Access Compliance Report

Public Rights-of-Way

(Curb Ramps)

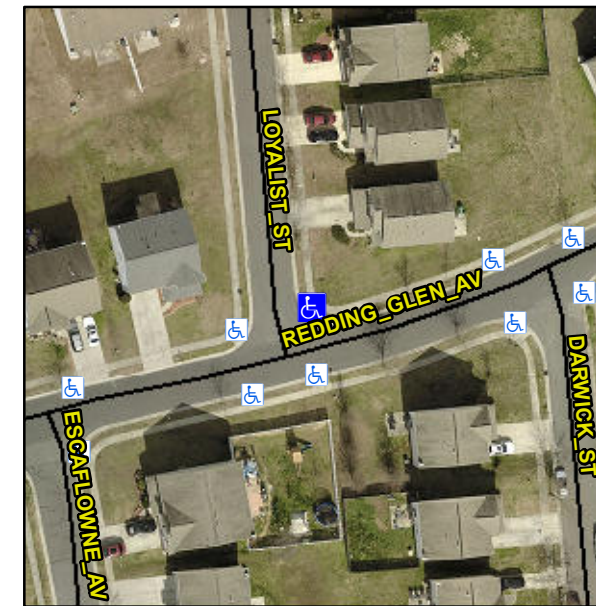
Intersection ID: 44480	Main Street: LOYALIST_ST	Cross Street: REDDING_GLEN_AV	Location: NE
ADA ID: C709D1D1A145	Ramp Type: BlendTrans1	Initial Pass/Fail: Fail	Overall Compliance: No
Codes/Mitigation Info/Possible Solution			Severity Score: 25
			Field Measurements/Component Compliance

Not Found, R304.5.3

Compliance	Description	Data	Compliance	Description	Data
N/A	Ramp Length (in)	48.5	Yes	BlendTrans Slope (%)	2.4
Yes	Ramp Width (in)	48.0	No	BlendTrans XSlope (%)	8.4
N/A	Flare Type LT	N/A	N/A	Flare Type RT	N/A
N/A	Flare Slope LT (%)	N/A	N/A	Flare Slope RT (%)	N/A
N/A	Flare Traversable LT?	N/A	N/A	Flare Traversable RT?	N/A
N/A	Landing Length (in)	N/A	N/A	DWS Provided?	N/A
N/A	Landing Width (in)	N/A	N/A	DWS Contrast?	N/A
N/A	Landing Slope (%)	N/A	N/A	DWS Length (in)	N/A
N/A	Landing X Slope (%)	N/A	N/A	DWS Full Width?	N/A
N/A	Landing Curb? (Y/N)	N/A	N/A	DWS Offset (in)	N/A
N/A	Shared Landing?	N/A			
N/A	Gutter Ponding?	N/A	N/A	Gutter Slope (%)	N/A
N/A	Gutter Lip Ht (in)	N/A	N/A	Gutter X Slope (%)	N/A
N/A	Painted X Walk1?	No	N/A	Painted X Walk2?	No
	X Walk 1 Direction	To W		X Walk 2 Direction	To S
	X Walk 1 Width (in)	N/A		X Walk 2 Width (in)	N/A
	X Walk 1 Slope (%)	1.6		X Walk 2 Slope (%)	5.4
	X Walk 1 X Slope (%)	3.6		X Walk 2 X Slope (%)	1.6

N/A	Ramp inside XWalk1?	N/A	N/A	Ramp inside XWalk2?	N/A
	Road Slope (%)	3.9		Clear Space?	N/A
	Road X Slope (%)	1.9	N/A	Clear Space to XWalk (in)	N/A
N/A	Any Obstructions?	N/A	N/A	Storm Grate/Utility Hazard?	N/A
	Obstruction Type			Storm Grate/Utility Type	
		N/A			N/A
			Yes	Surface Condition? (G/P)	Good
			No	Curb Slope (%)	13.1

Remove & Replace Curb Ramp With Two New Directional Ramps or Equivalent.
